UNITED STATES PATENT AND TRADEMARK OFFICE

10/747,609

Office Action Summary

DETAILED ACTION

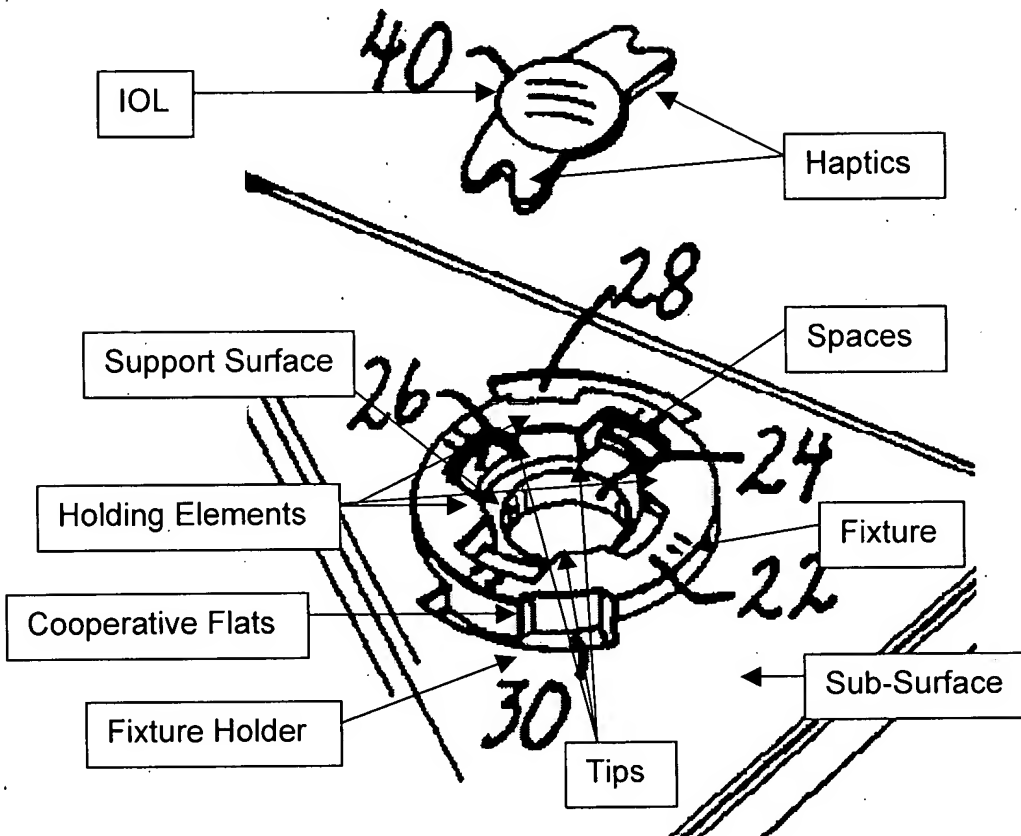
4. Claims 1-7 and 14-16 are **Finally** rejected under 35 U.S.C. 103(a) as being unpatentable over LaHaye (4269307) in view of Sarfarazi (6488708). LaHaye discloses an intraocular lens (IOL) assembly comprising, an intraocular lens device (40), a circular support surface (Figure 3) (see figure below), one or more annularly curved dovetail shaped holding elements spaced about and attached to the perimeter of said support surface (see figure below), said holding elements also including an inner-most tip and two diametrically opposed tips which define a diameter slightly smaller than the diameter of said IOL, whereby haptics of the IOL extend in spaces (see figure below)

between said lens holding elements, a fixture holder (see figure below) and a subsurface (see figure below) surrounding said support surface for removably mounting said fixture to said fixture holder and said fixture including cooperating flats (see figure below) for fixing the rotational orientation between the fixture holder, but lacks, an intraocular lens having first and second optics. However, the examiner would like to note that LaHaye discloses that the holder has, "universal application" for holding numerous types of intraocular lenses (IOL) (Column 3, Lines 17-23 and Column 4, Lines 62-66). Sarfarazi teaches of one such intraocular lens that has first (42) and second optics (44) interconnected by one or more haptics (46). Therefore, it would have been obvious to one of ordinary skill in the art at the time the invention was made to modify the intraocular lens, of LaHaye, with an intraocular lens having first and second optics, in view of Sarfarazi, in order to provide an intraocular lens that restores a patient's multi-focal vision following cataract extraction.
